SERVICE DIRECTIVE BULLETIN NO. 0097

1. SUBJECT: Incorrect Installation Hardware on Seat Belt Bracket, P/N 28-11467-1
2. MODEL: F-28F, 280F, and 280FX
3. EFFECTIVITY: All F-28F serial numbers prior to S/N 816
All 280F serial numbers
All 280FX serial numbers prior to S/N 2108

Figure 2. Seat Belt Bracket Installation Hardware

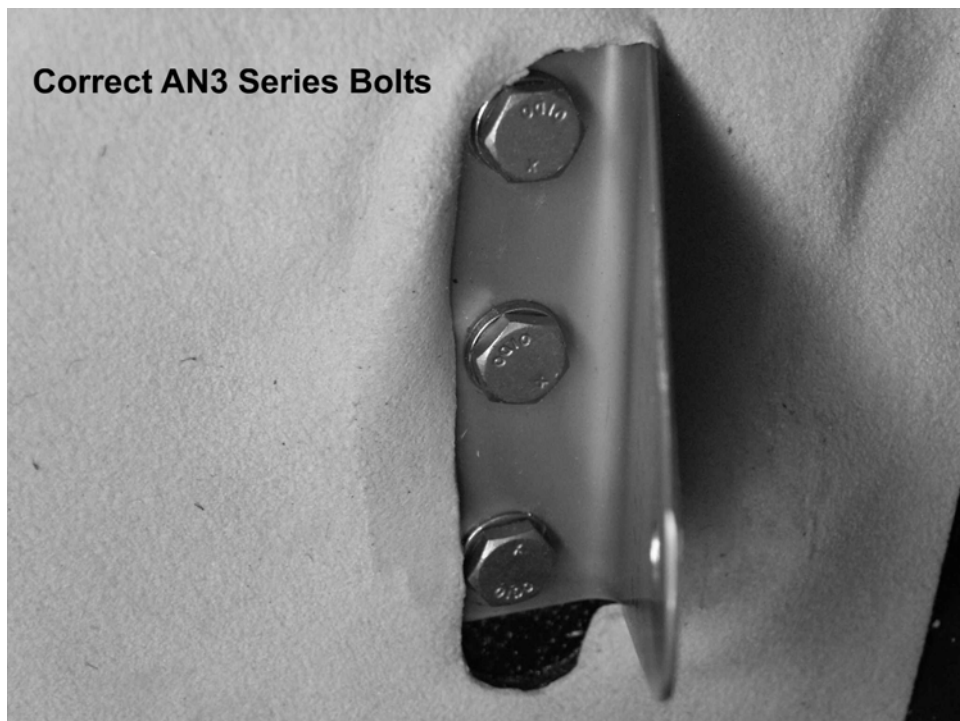
During final inspection of a production F-28F aircraft, an inspector found the seat belt brackets, P/N 28-11467-1, installed with AN525 series screws instead of the AN3 series bolts required by the engineering drawings. A review of the production records did not establish how many aircraft potentially have incorrect hardware installed.

- E. Inspect the seat belt bracket installation for the correct hardware (See Figure 2).
- F. If AN3 series bolts are installed in the seat belt brackets, reassemble the aircraft and return it to service.
- G. If AN525 series screws are installed in the seat belt brackets, remove the screws and replace with AN3-5A bolts and AN960-10 washers. After replacing the hardware, reassemble the aircraft and return it to service.

Description	Part Number	Quantity
Bolt	AN3-5A	6 Ea
Washer	AN960-10	6 Ea
